LAND USE APPLICATION COMPLETENESS REVIEW

Subject Property: 1105 Front Street NE

Reference Nos.: 24-106451-PLN (Class 3 Site Plan Review, Tentative Subdivision Plan, Class 1 & 2 Adjustment, Class 2 Driveway Approach Permit)

**TENTATIVE PLAT
 THE CANNERY
 FUND
 SALEM, OREGON**

1 1st FLOOR PLAN
1/8" = 1'-0"

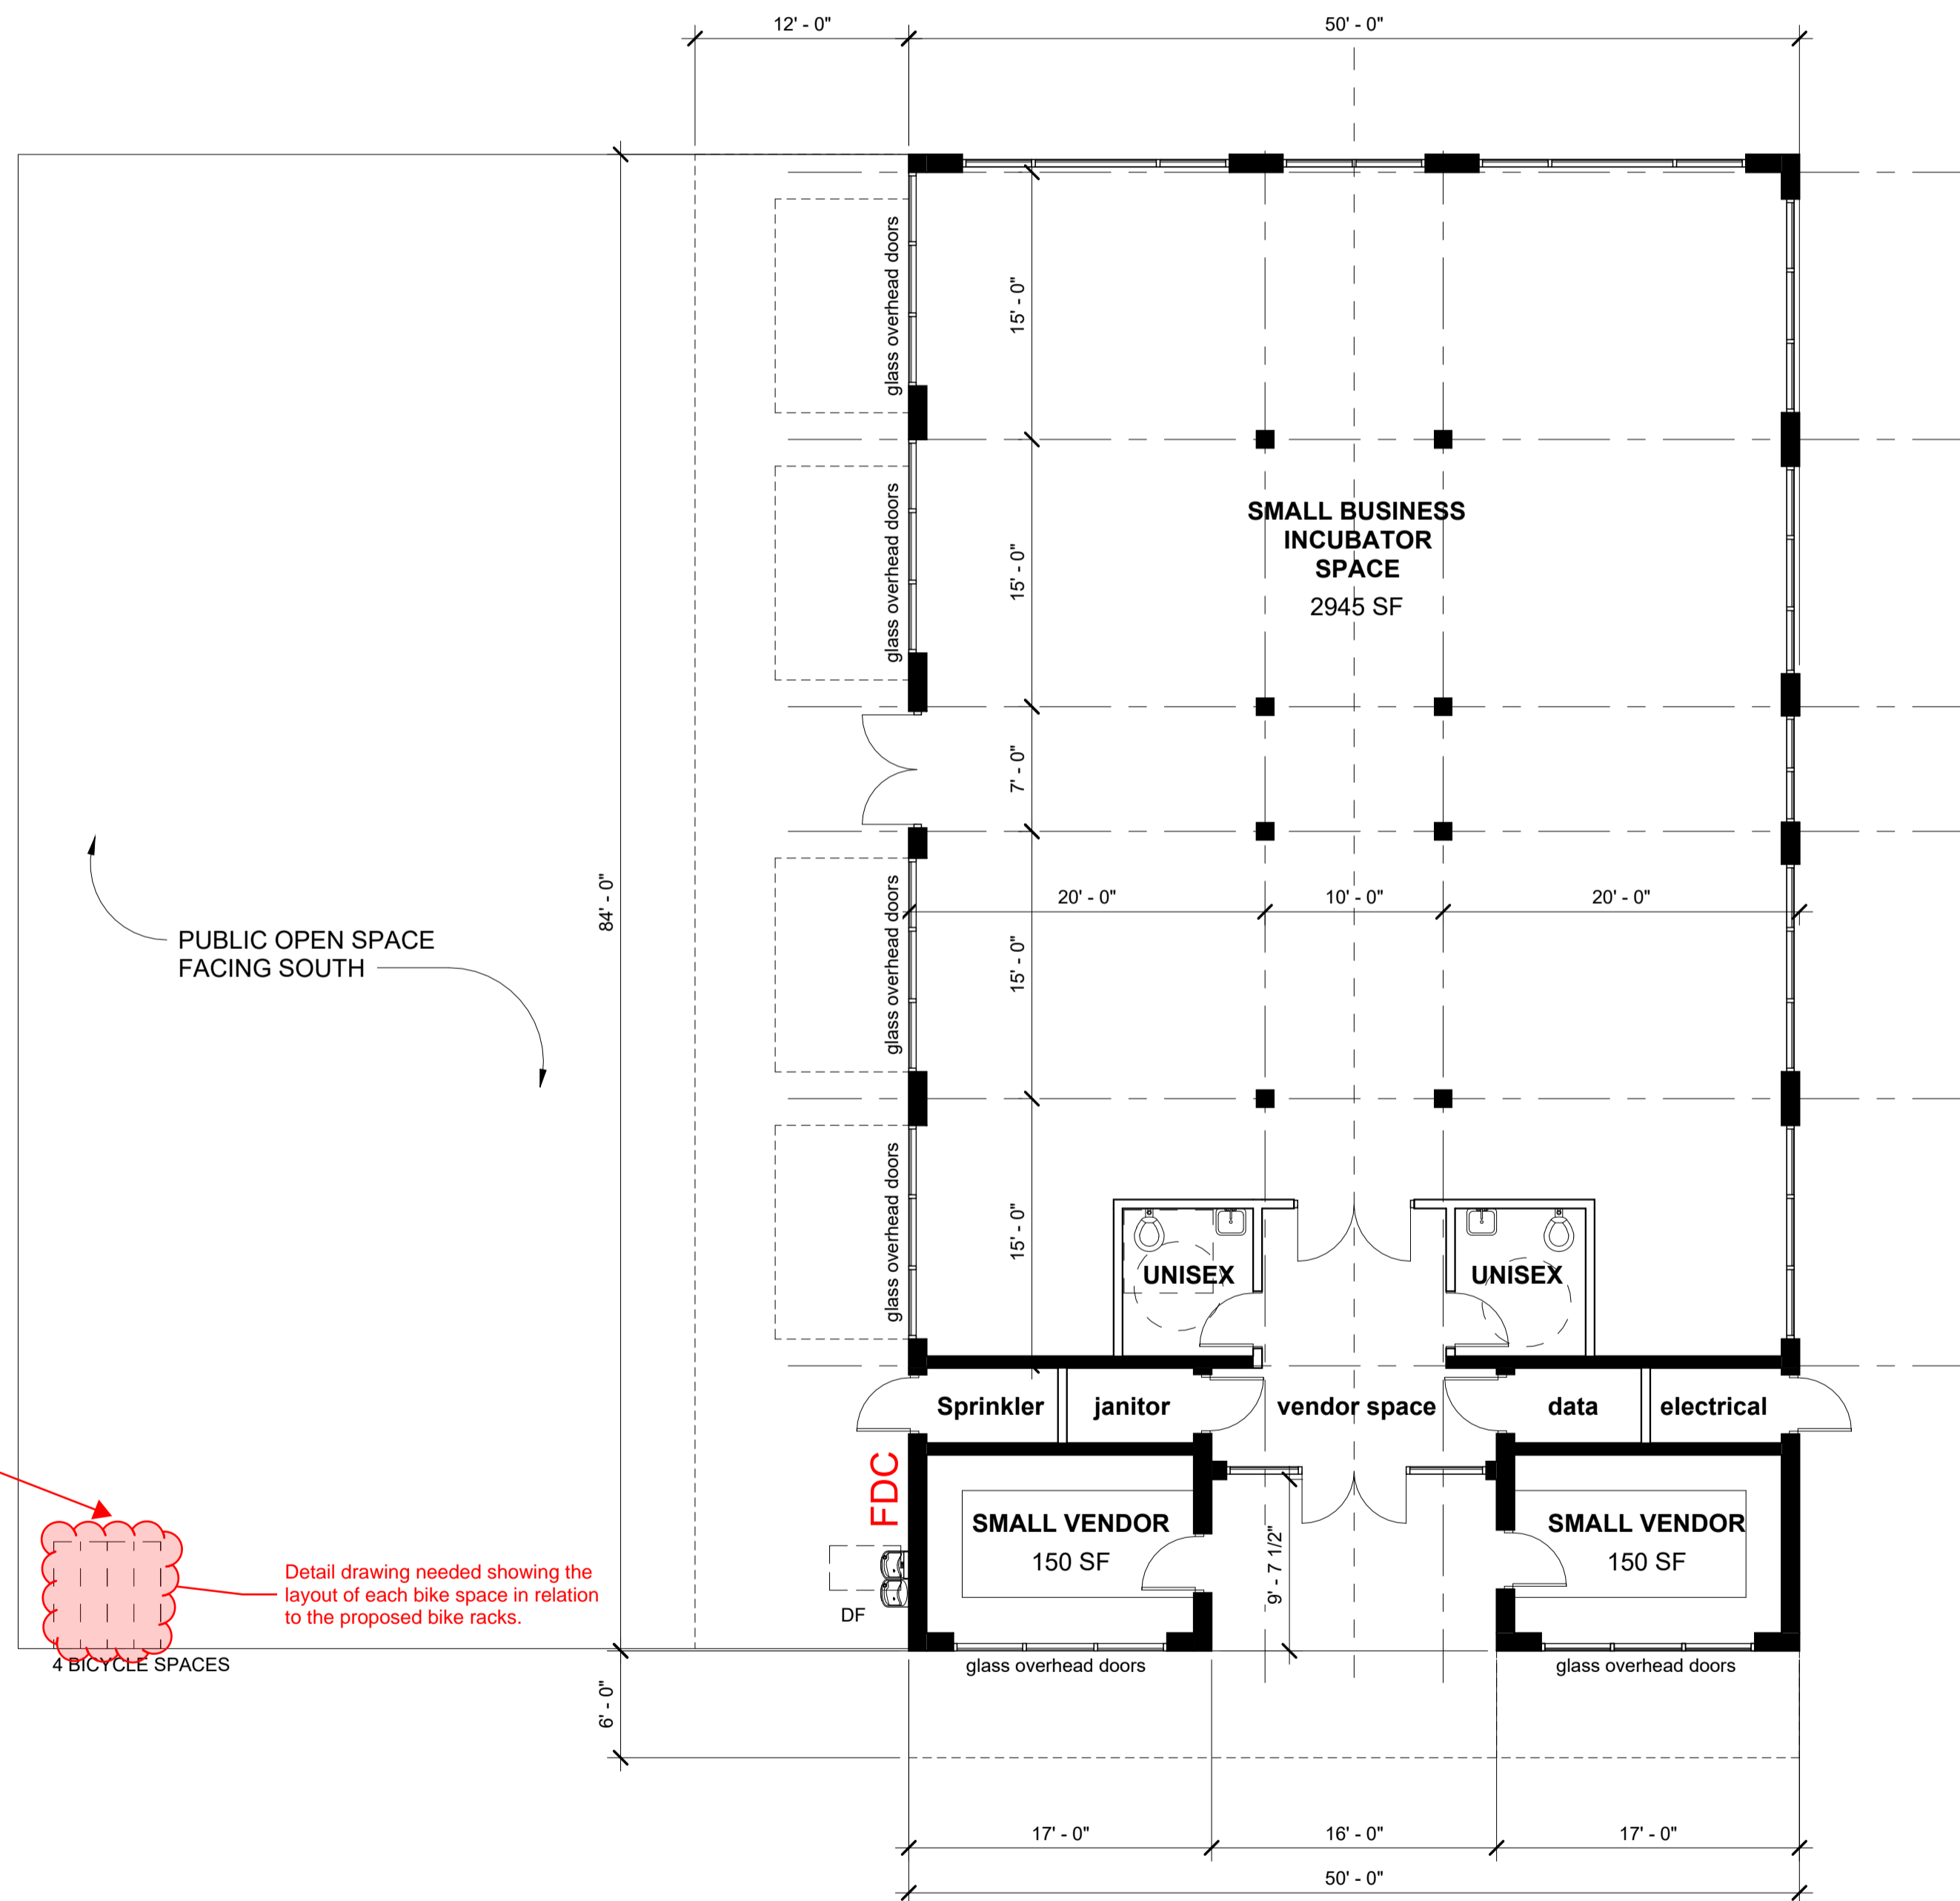
Per SRC 806.060(a)(1), short-term bicycle parking shall be located within a convenient distance of, and be clearly visible from, the primary building entrance. In no event shall bicycle parking be located more than 50 feet from the primary building entrance, as measured along a direct pedestrian route.
